**TOWN OF BROOKLYN
PLANNING AND ZONING COMMISSION
Regular Meeting Agenda
Tuesday, July 20, 2021 6:30 p.m.**

ENGINEERING PLAN REVIEW PERTAINING TO A 2-LOT RESUBDIVISION (ASSESSOR'S MAP 41, LOT 47) 40 ALMADA DRIVE BROOKLYN, CT (May 3, 2021)

The comments contained herein pertain to my review of plans for a proposed 2-lot residential resubdivision located at 40 Almada Drive in Brooklyn, Connecticut, consisting of ten (10) sheets, prepared for Paul R. Lehto by Archer Surveying, LLC and CLA Engineers, dated November 13, 2020 and March 31, 2021, respectively. Comments pertain to both wetlands and planning and zoning regulations.

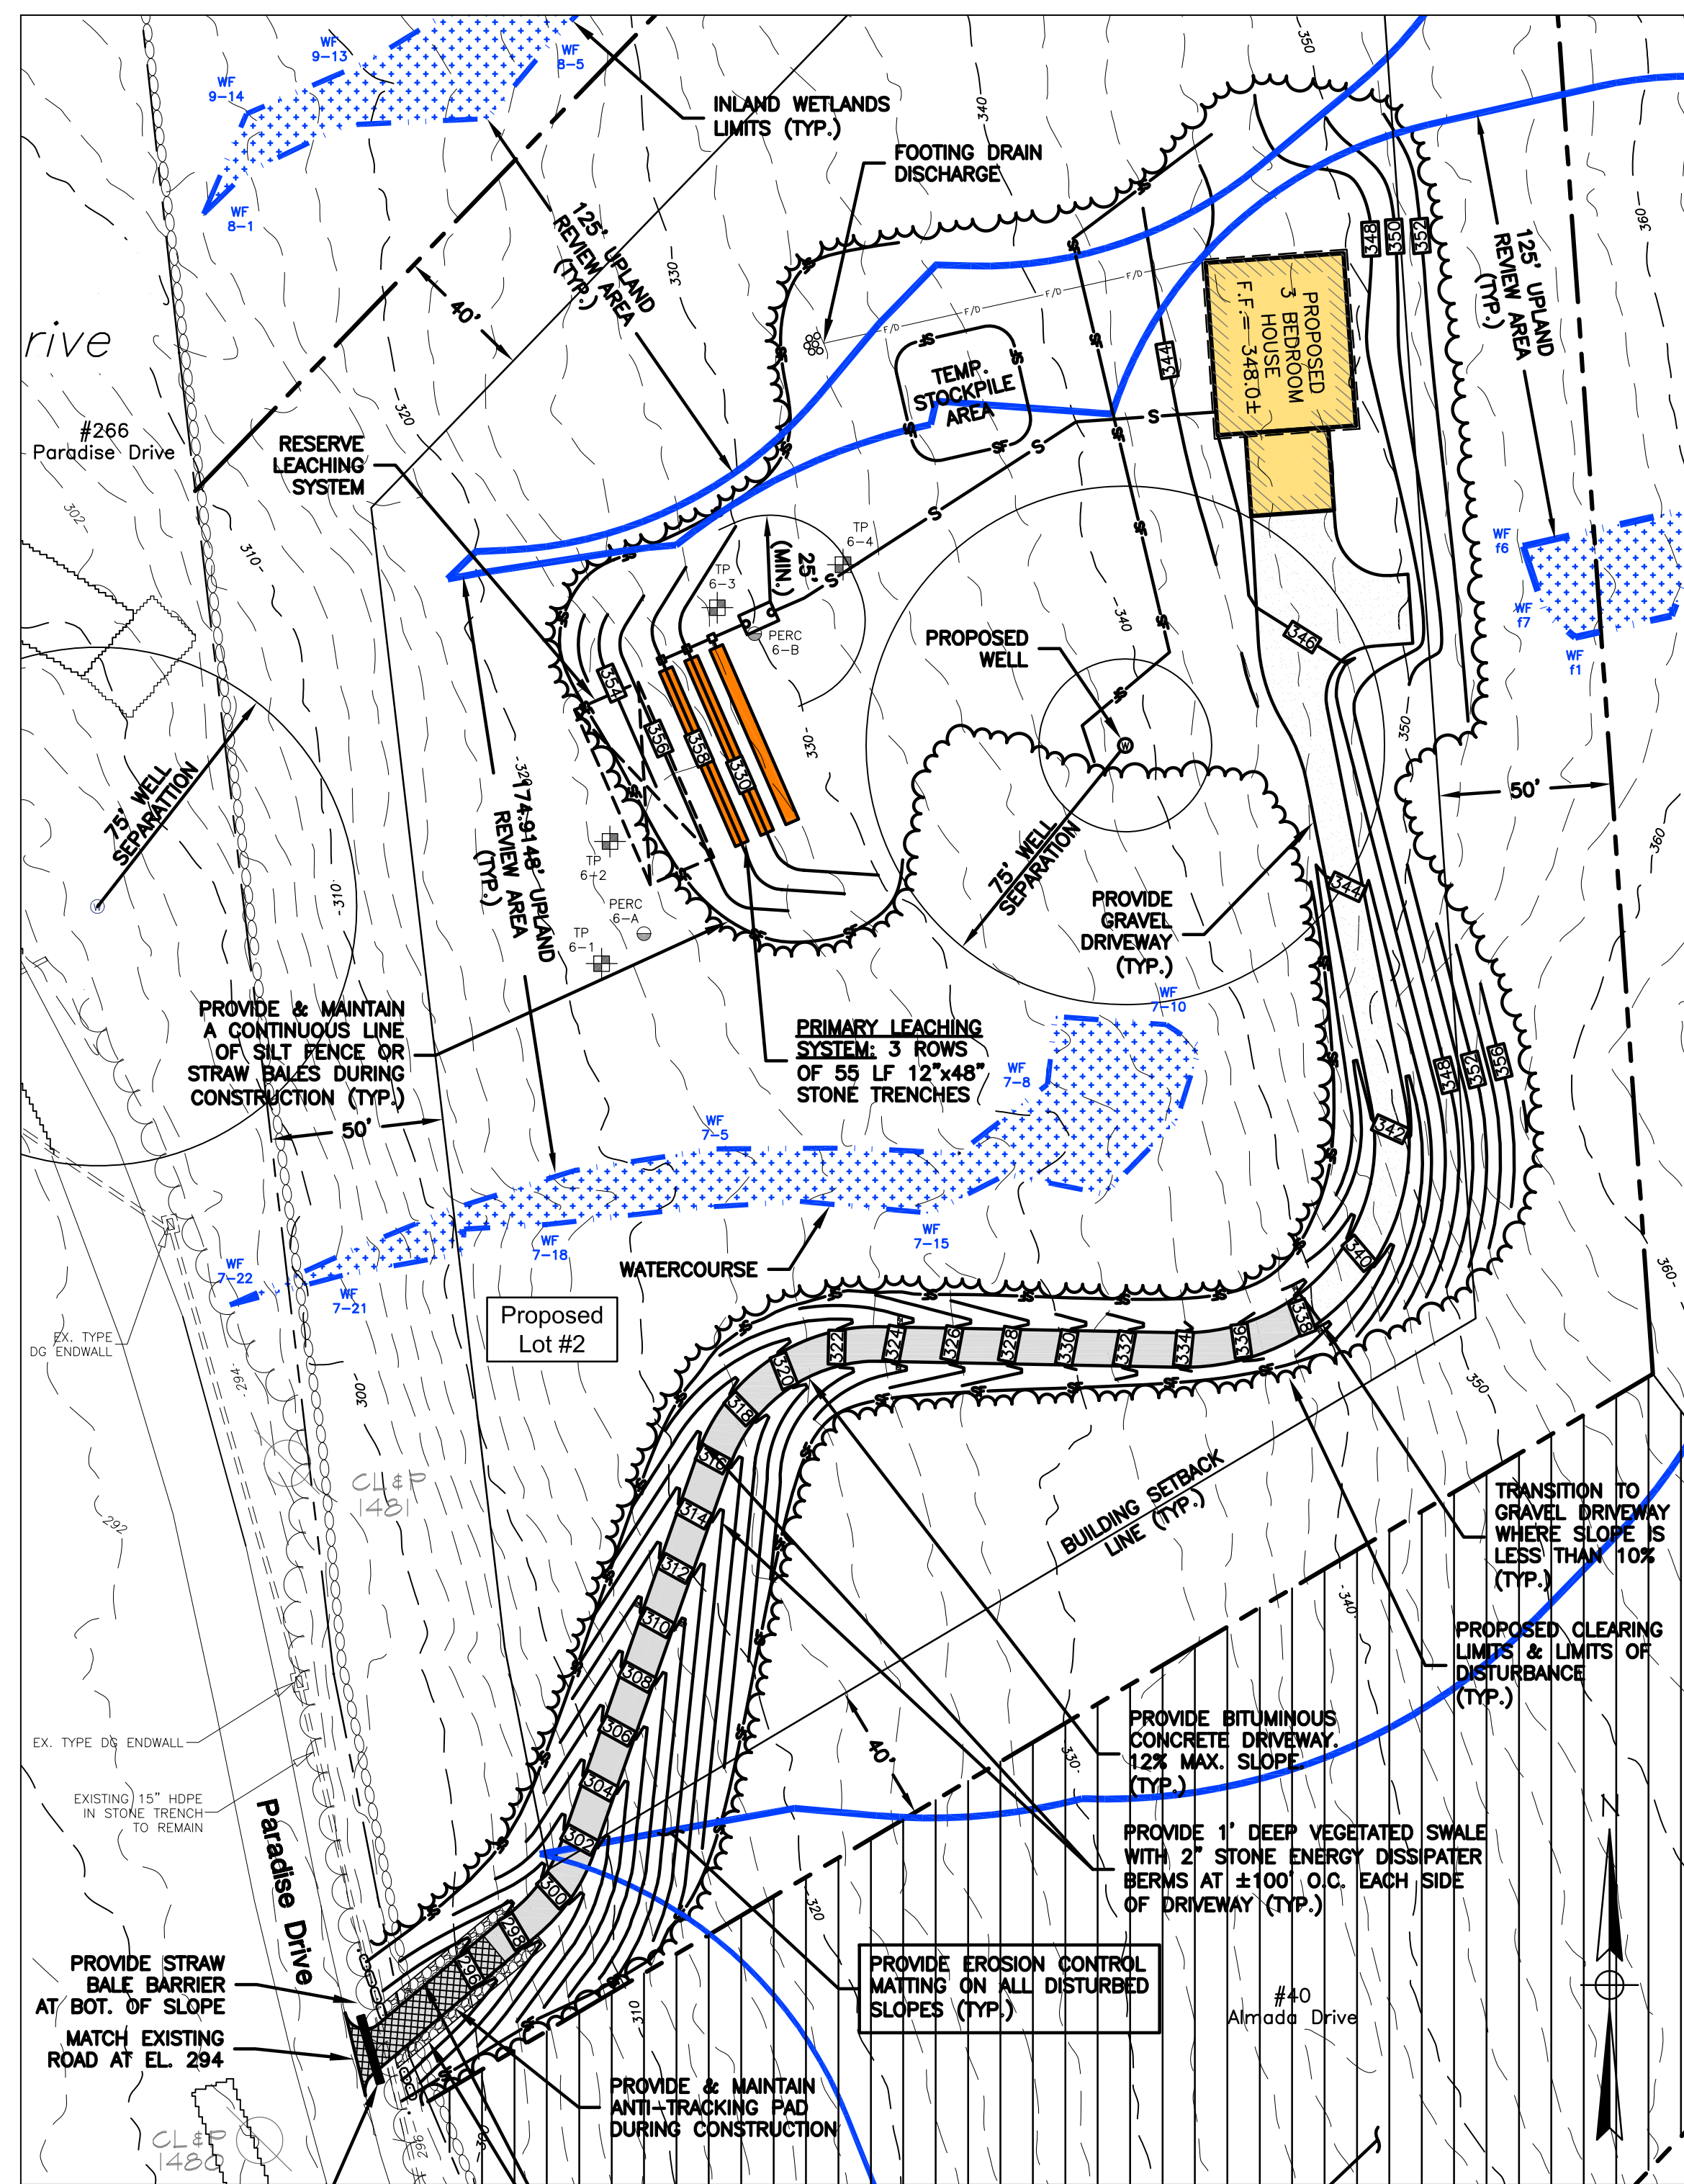
Considering these observed conditions, the proposed paved driveway needs careful consideration with respect to the proposed cuts that remove more than 24" of existing soil to form new slopes.

2. There is no indication on the plan for the conveyance of water in the existing Paradise Drive swale to pass under the apron of the proposed driveway. This needs to be evaluated with drainage calculations submitted for review.

3. Due to the steepness of the Lot 2 driveway gradient and it also being paved, formal drainage swales with velocity attenuators need to be located along both edges of the driveway from Elevation 242 down to Paradise Drive. This is to help guard against degradation of the existing drainage swale, especially during heavy rainfall events. A construction detail is also required.

4. It is not apparent from looking at the plan how soil erosion and sediment transport from driveway construction will minimize sediment transport to the Paradise Drive drainage swale and underground drainage system. This needs an explanation.

Comment has been addressed.

Comment has been addressed.

Comment has been addressed.

Comment has been addressed.

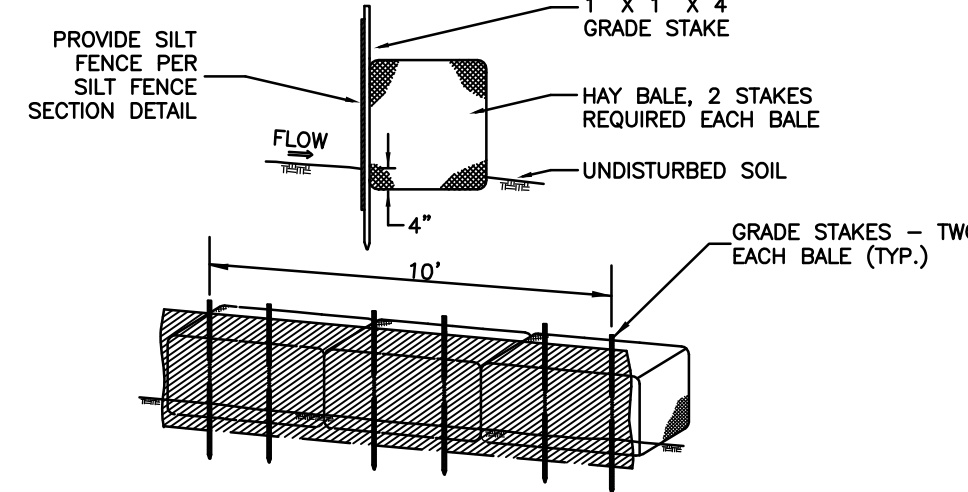
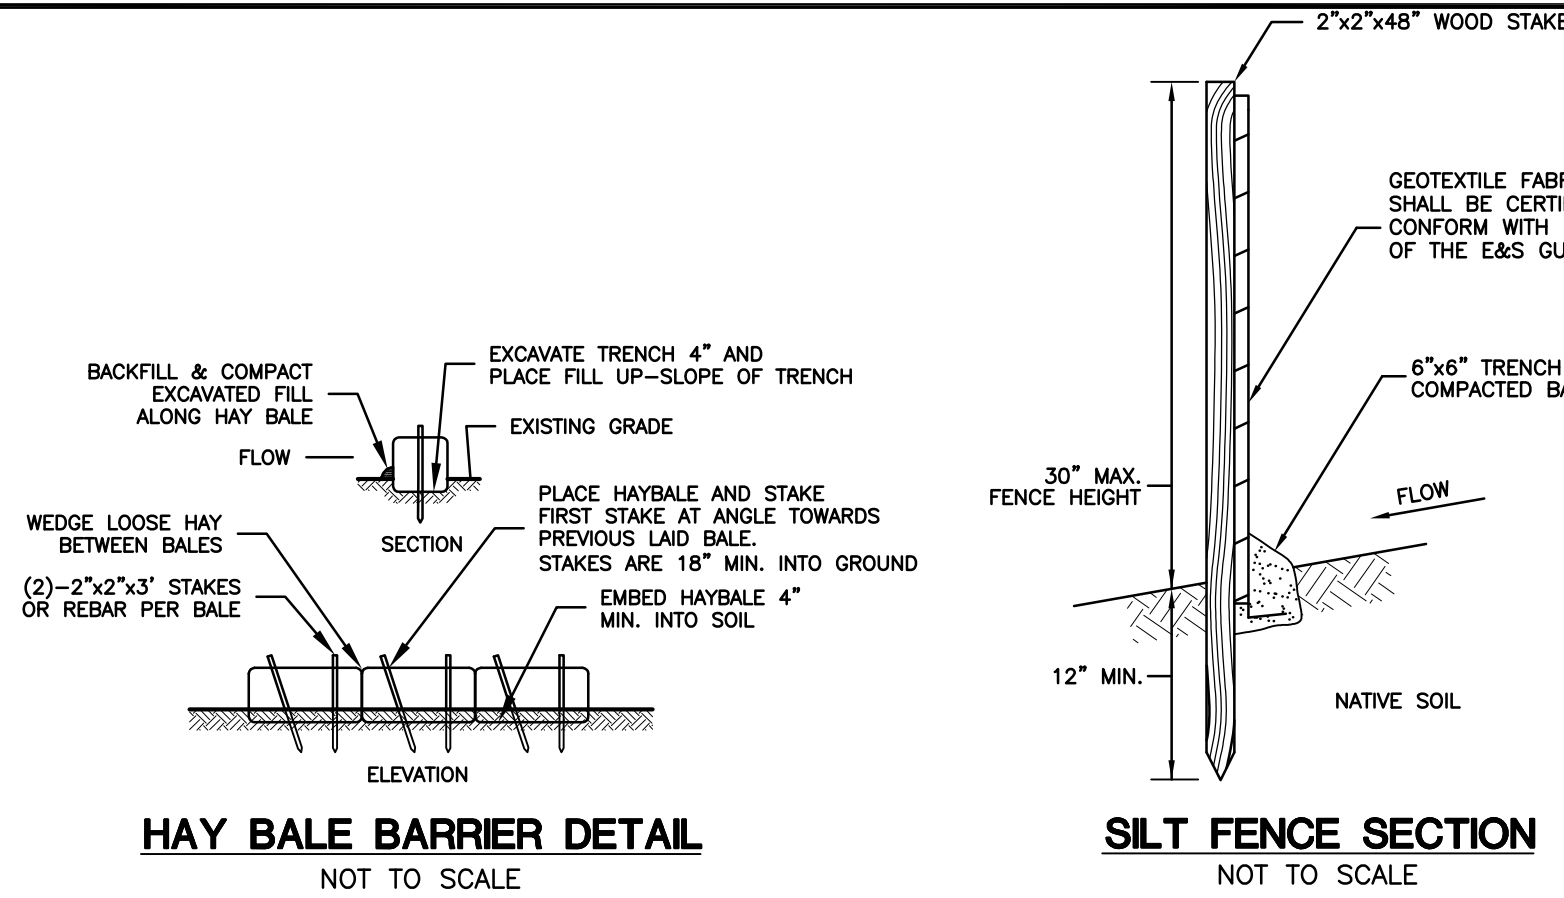
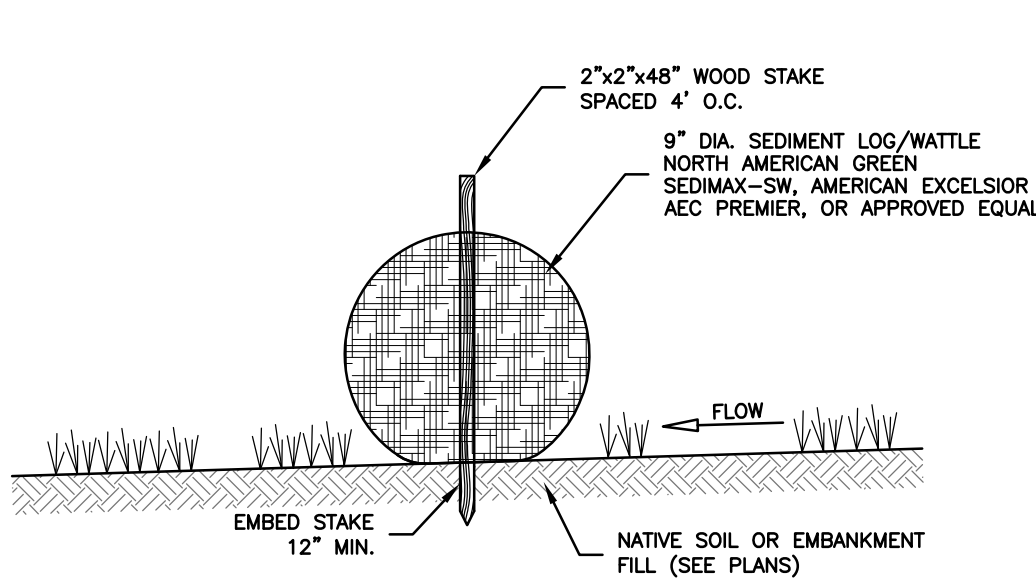
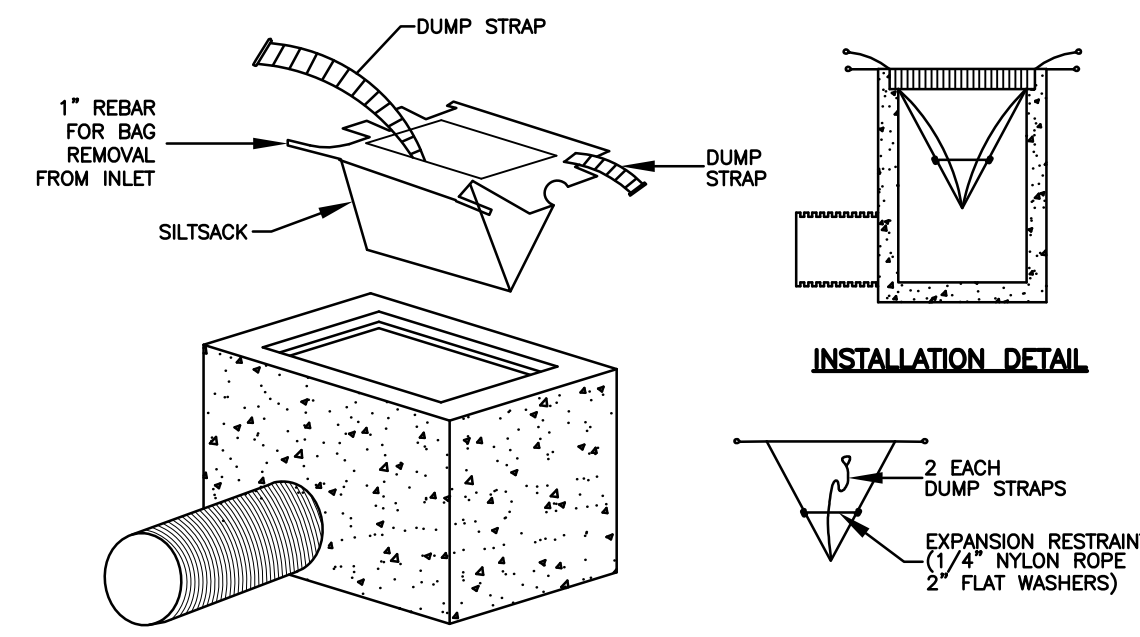
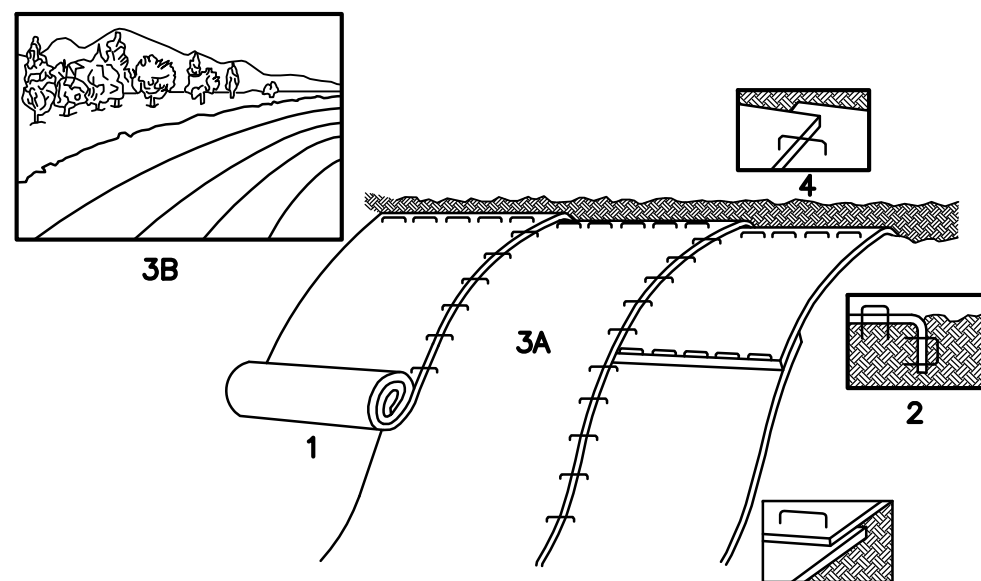
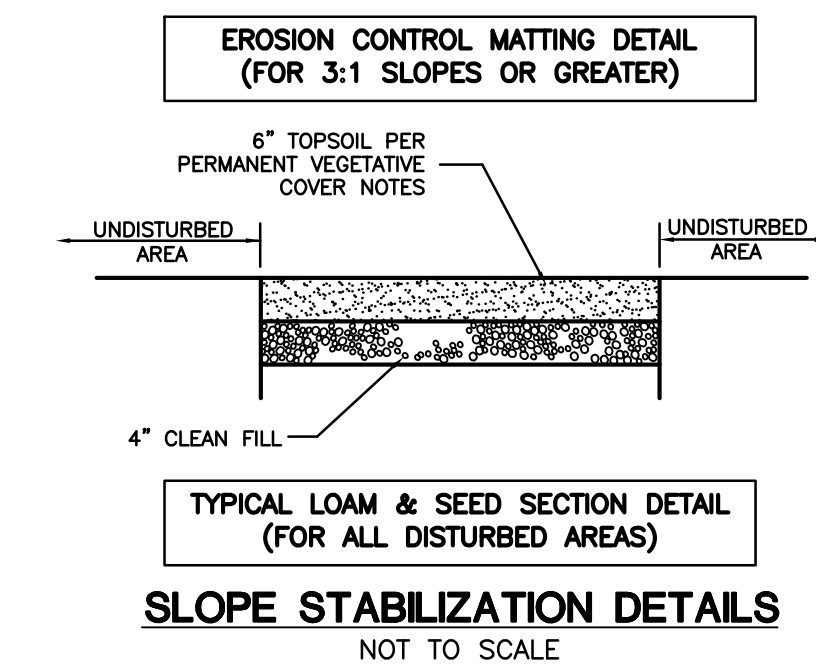
2. Note 2 under "Post Construction" it is stated that the *"Proposal is for the Town of Brooklyn to accept Almada Drive Extension as a town road that will be incorporated into the town MS4 Operations and Maintenance Program."* First of all, a designation of the Almada Drive Extension cannot be found on any plan submitted for review. Secondly, has this statement been agreed to by town staff and will the citizens of Brooklyn be the deciding body on whether or not this becomes a town road? If a privately owned road, MS4 can still be observed by its responsible party(s). This note needs an explanation as to why it appears here.

Post construction notes have been deleted from plan.
